City of Pryor Creek -Bond Issue 2018 Police/Fire Energency and City Library

# Pryor Emergency Services Center & Library Renovation Project Monthly OAC Meeting Thursday, December 16th, 2021

Project: 1903a Pryor Police/Fire Emergency Services Center and Library Additions

# Proposal Request #03 : Site Plan Storage Bldg Changes

PARTIAL PLAN A2.1 BOOKING 172B - COUNTER TOP

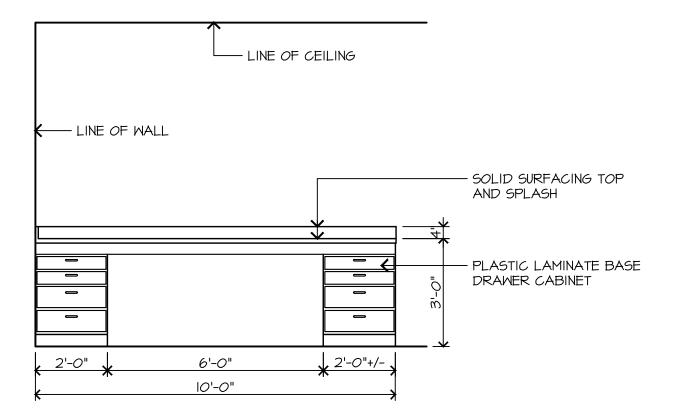
- Remove two detention area windows from room 172B. (Window mark number 19.)
- Move cuff bench in room 172B.
- Add built-in millwork to room 172B.

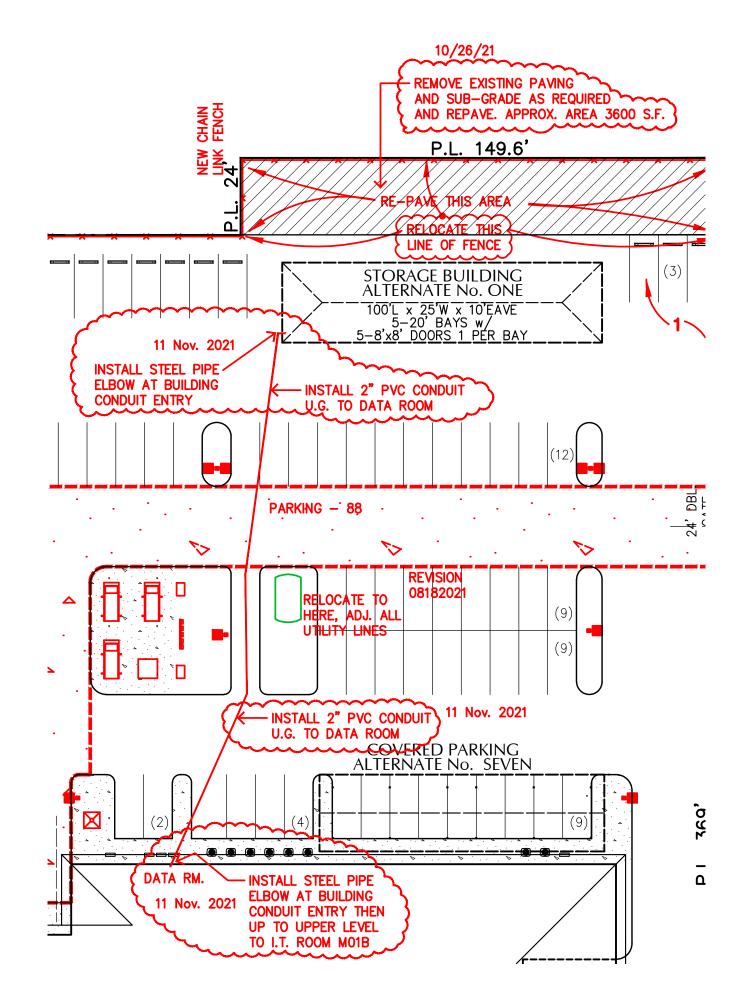
- Added 2" raceway from Alternate Storage Building to Data Room.
- Fence changes to be included in PR #04. Excluded from this PR.
- Paving behind Alternate Storage Building to be included in PR #04. Excluded from this PR.

# **Proposal Request #04 : Fire Marshal Comment Changes**

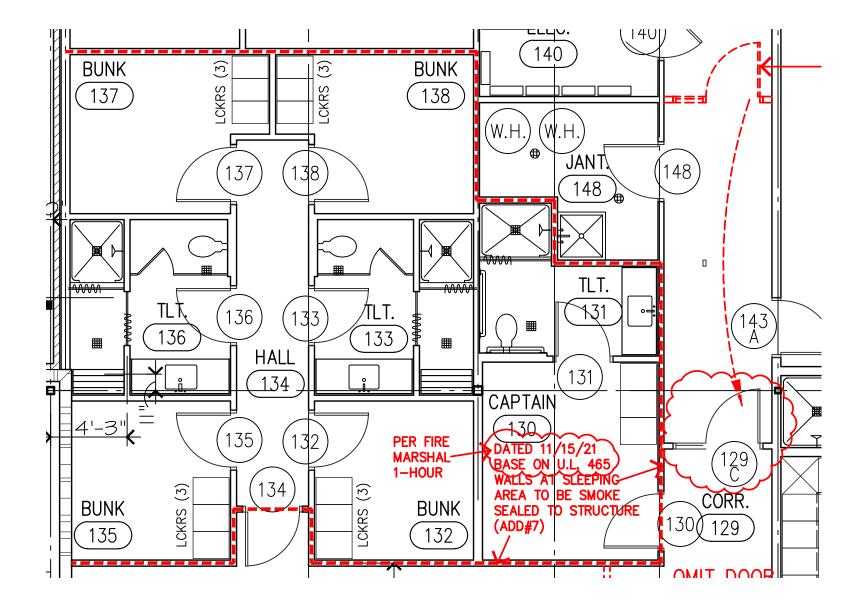
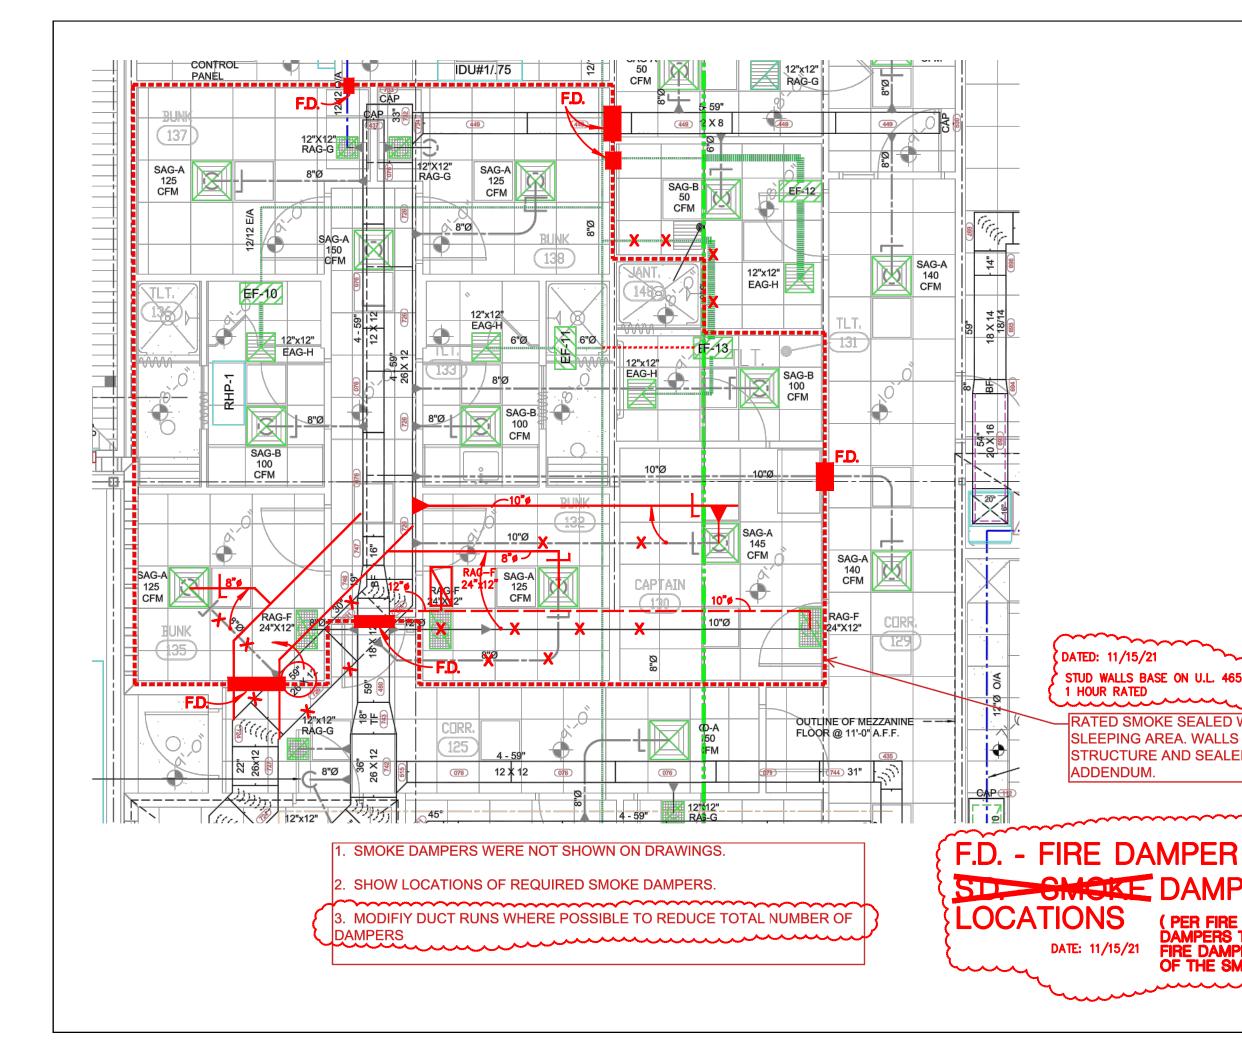
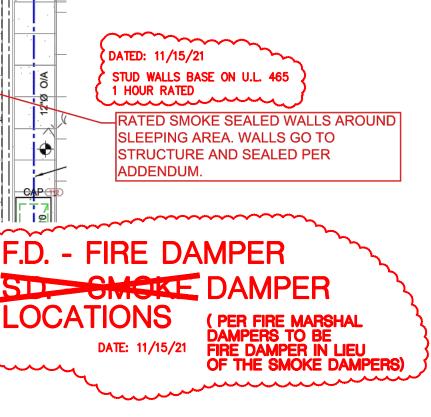
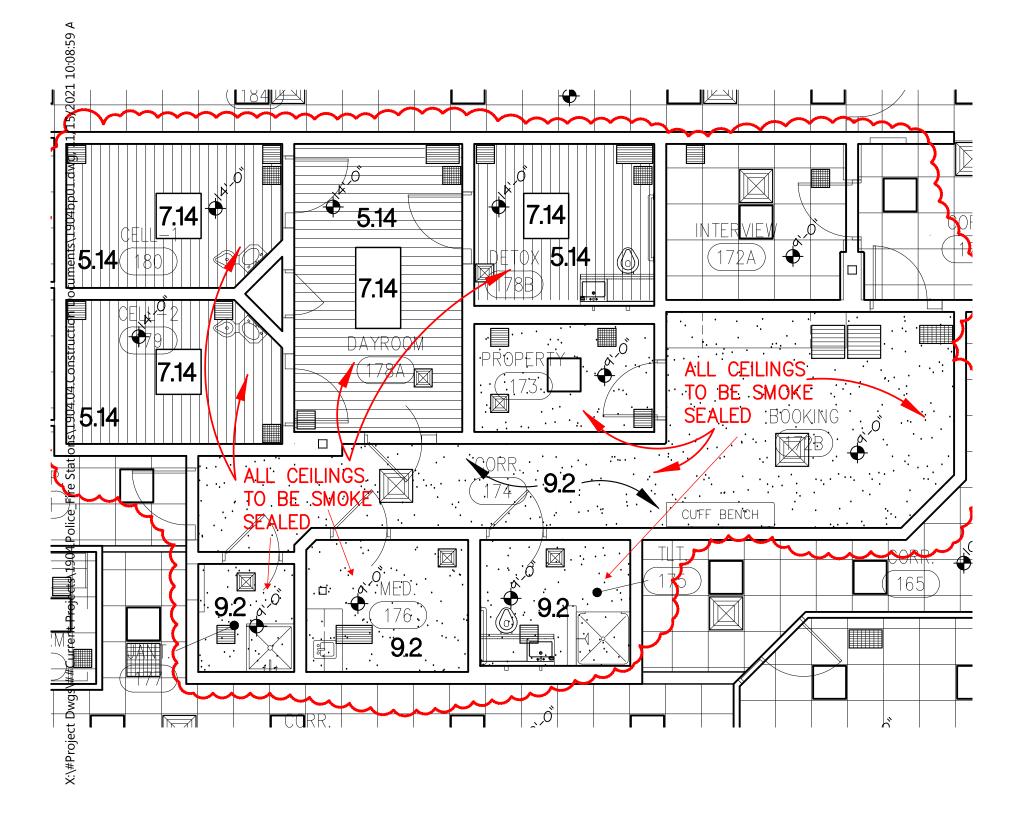
- Change smoke dampers in sleeping quarters to fire dampers.
- Changes to mechanical duct layout in sleeping quarters.
- Change ceiling from lay-in acoustical to drywall hard lid ceiling in Corridor 174, Booking 172B, and Property 173.
- Smoke seal ceiling to walls in rooms 172B, 173, 174, 175, 176, 177, 178A, 178B, 179, and 180.
- Excludes moving door 129C. This change to be included in a future Proposal Request.

### Sheet E1.1

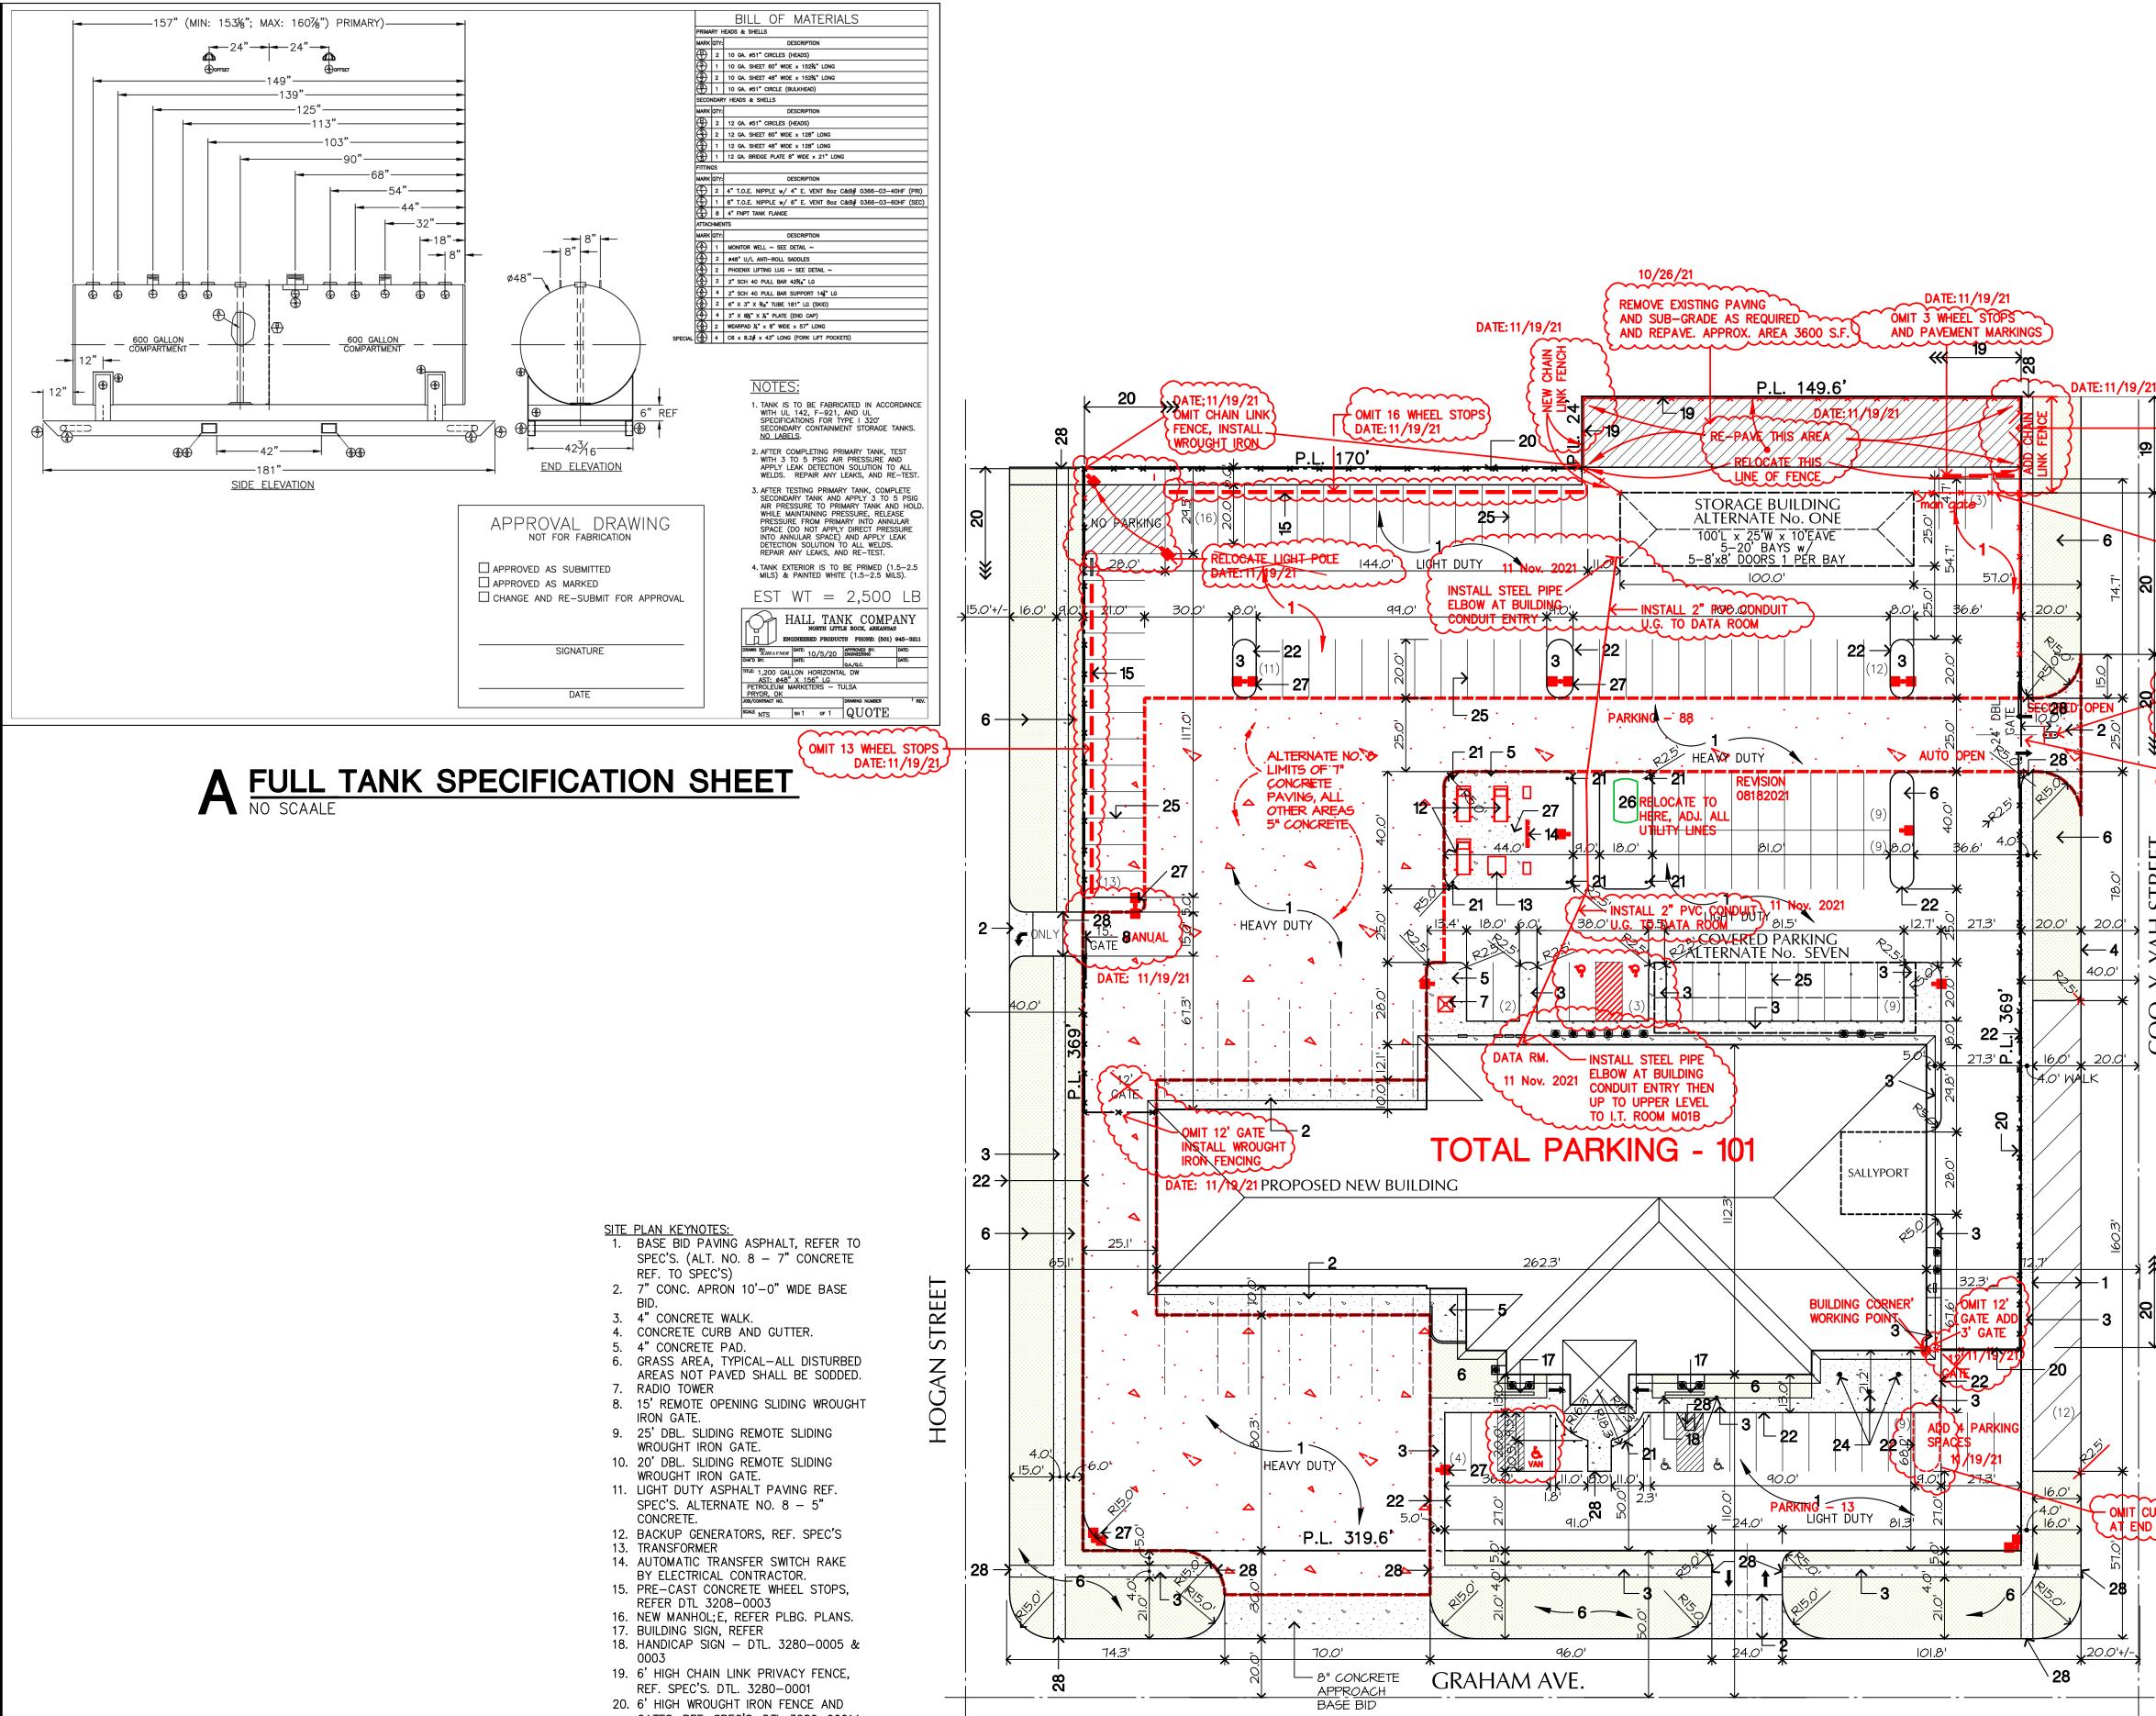
- Add power and data outlets, boxes, conduit, wiring, and drops. Provide coax cable to each TV location.
